Access Compliance Report

Public Rights-of-Way

Intersection ID: 16072	Main Street: MONROE_RD	Cross Street: RICHLAND_DR	Location: NW
ADA ID: 93B75DE648AB	Ramp Type: Perp	Initial Pass/Fail: Fail	Overall Compliance: No
		Severity Score: 8.75

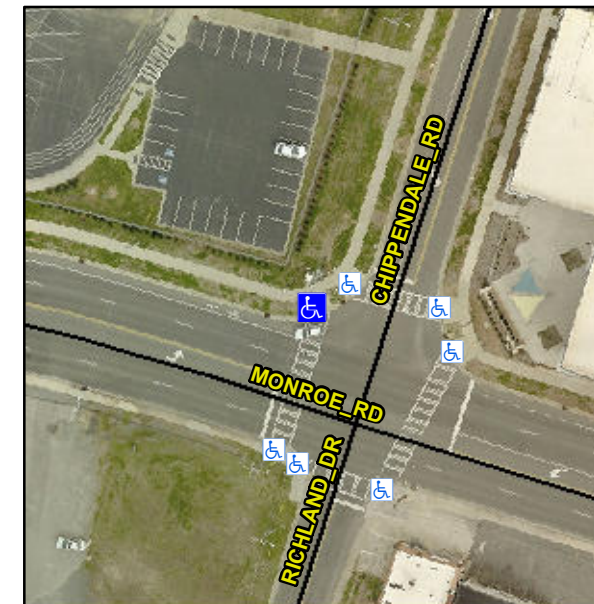
Not Found, R304.5.1

Compliance	Description	Data	Compliance	Description	Data
N/A	Ramp Length (in)	94.0	Yes	Ramp Slope (%)	6.2
No	Ramp Width (in)	46.5	Yes	Ramp XSlope (%)	0.3
N/A	Flare Type LT	N/A	N/A	Flare Type RT	N/A
N/A	Flare Slope LT (%)	N/A	N/A	Flare Slope RT (%)	N/A
N/A	Flare Traversable LT?	N/A	N/A	Flare Traversable RT?	N/A
N/A	Landing Length (in)	N/A	N/A	DWS Provided?	N/A
N/A	Landing Width (in)	N/A	N/A	DWS Contrast?	N/A
N/A	Landing Slope (%)	N/A	N/A	DWS Length (in)	N/A
N/A	Landing X Slope (%)	N/A	N/A	DWS Full Width?	N/A
N/A	Landing Curb? (Y/N)	N/A	N/A	DWS Offset (in)	N/A
N/A	Shared Landing?	N/A			
N/A	Gutter Ponding?	N/A	N/A	Gutter Slope (%)	N/A
N/A	Gutter Lip Ht (in)	N/A	N/A	Gutter X Slope (%)	N/A
N/A	Painted X Walk1?	Yes	N/A	Painted X Walk2?	N/A
	X Walk 1 Direction	To S		X Walk 2 Direction	N/A
N/A	X Walk 1 Width (in)	114.0	N/A	X Walk 2 Width (in)	N/A
	X Walk 1 Slope (%)	0.3		X Walk 2 Slope (%)	N/A
	X Walk 1 X Slope (%)	0.5		X Walk 2 X Slope (%)	N/A

Remove & Replace Entire Ramp.
